NEC Microcomputer Technical Information

μPD178078 μPD178098 μPD178098A Subseries Usage Restrictions		Document No.	SBG-T-2492-E	1/1
		Date issued	September 26, 2001	
		Issued by	Microcomputer Engineering Dept. Solution Engineering Div. NEC Electron Devices NEC Corporation	
Related documents	User's manual (U12790EJ1V0UM00)	Notification classification	√	Usage restriction
	Data sheet (U12885EJ3V0DS00)			Upgrade
	Data sheet (U12920EJ1V0DS00)			Document modification
	Data sheet (U15209EJ1V0DS00)			Other notification

Item 1. Restriction on IEBus communication among three units

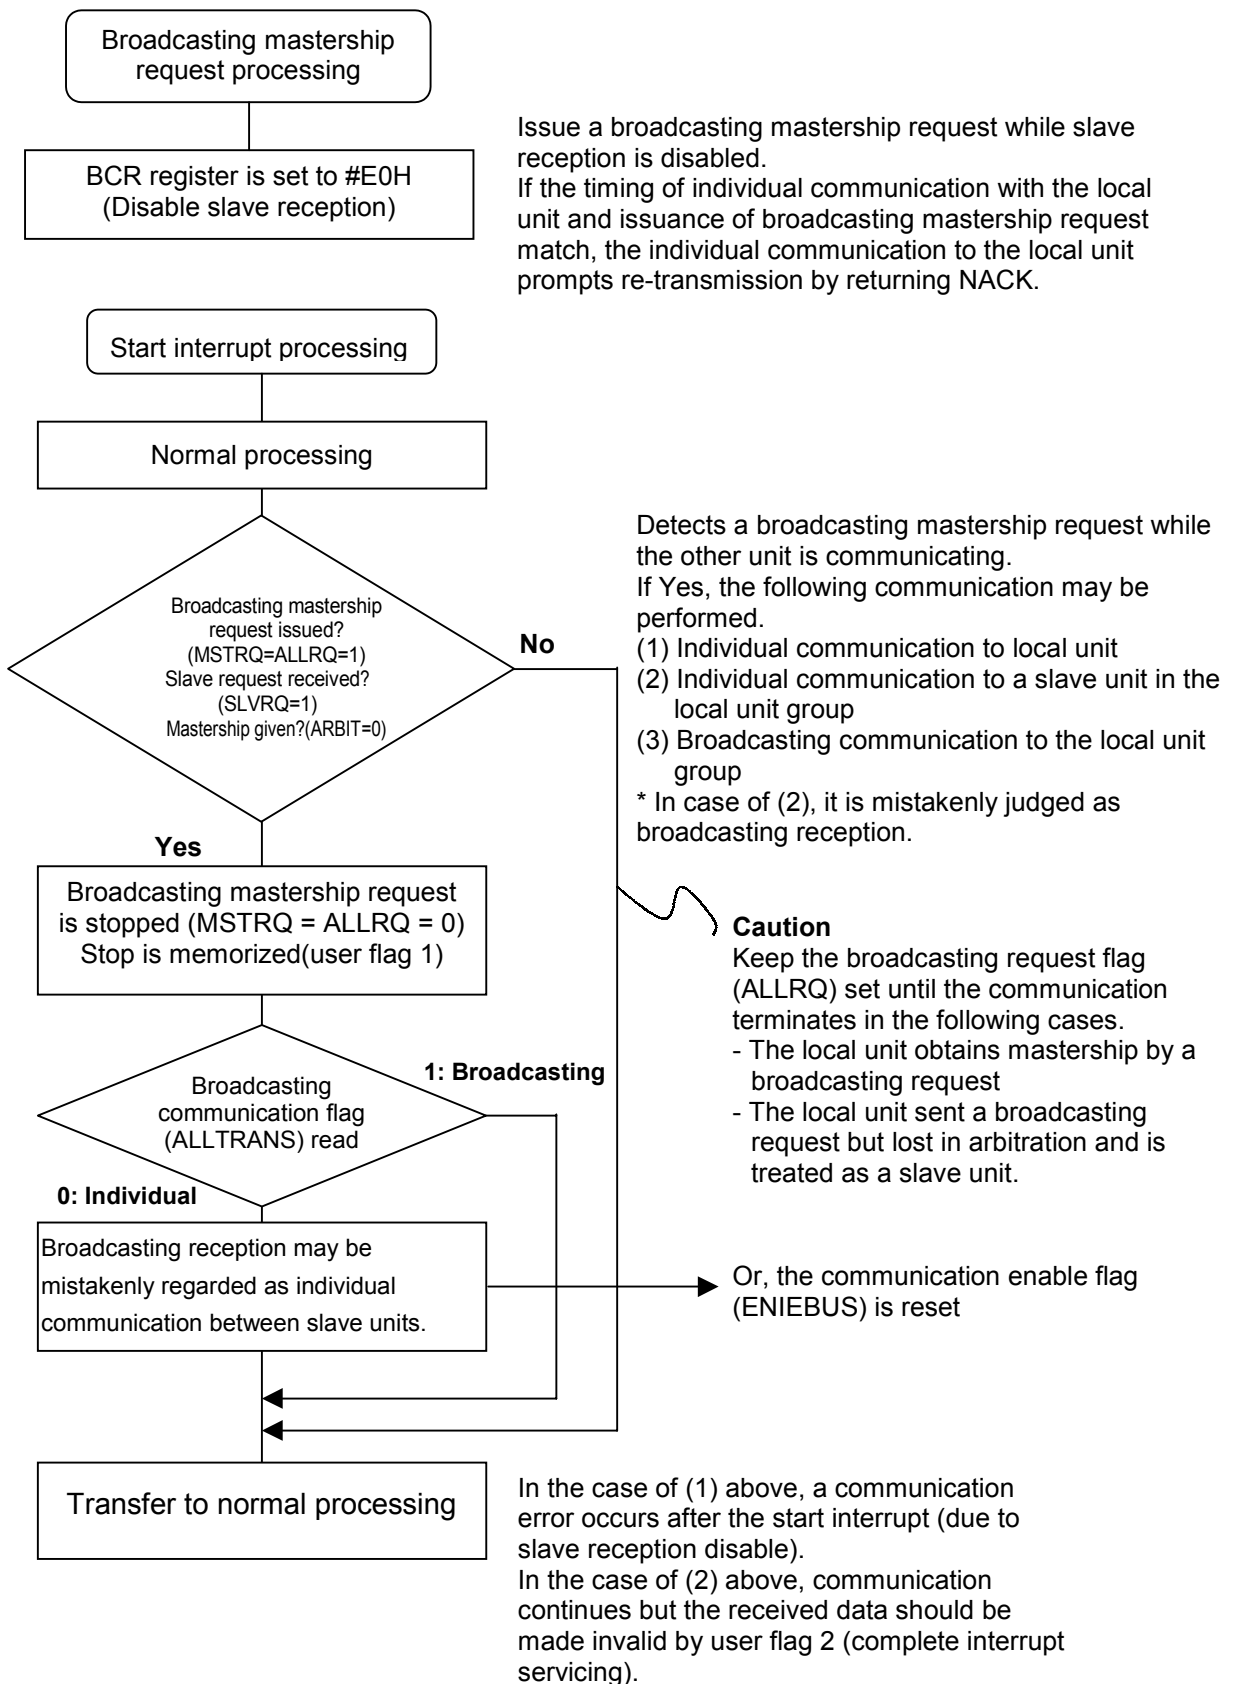
This error occurs only when the local unit issues a broadcasting mastership request during the period between the broadcasting field and bit 8 of the slave address field in individual communication between slave units (T2 in the figure below).

This error occurs only when the local unit issues a broadcasting mastership request during the period from bits 7 to 0 in the slave address field (T3 in the figure below).

- Disable slave reception when the broadcasting mastership request is issued (BCR = #E0H)
- If a slave request is detected (SLVRQ = 1) in the start interrupt servicing after a broadcasting mastership request is issued, clear the broadcasting mastership request flag. At this time, the subsequent data can be made invalid if the broadcasting communication flag (ALLTRANS) has been cleared to 0.

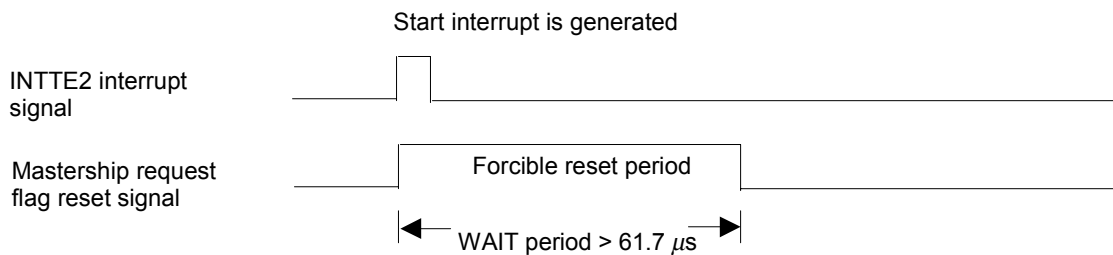
The mastership request reset signal is generated during the following period.

The mastership request flag (BCR0.6) will not be set (1) even if it is requested (BCR0.6 ← 1) in this period. This period is the same as the ACK width. The ACK time is defined as follows according to the IEBus specification.

The mastership request reset signal is generated for 61.70 μs max. Therefore, any mastership request sent in this period cannot be acknowledged.

After the start interrupt is generated, insert the WAIT time in the above figure and then set (1) the mastership request flag (BCR.6) to request the mastership.

The mastership request flag will not be acknowledged even if it is set (1) in the WAIT time.
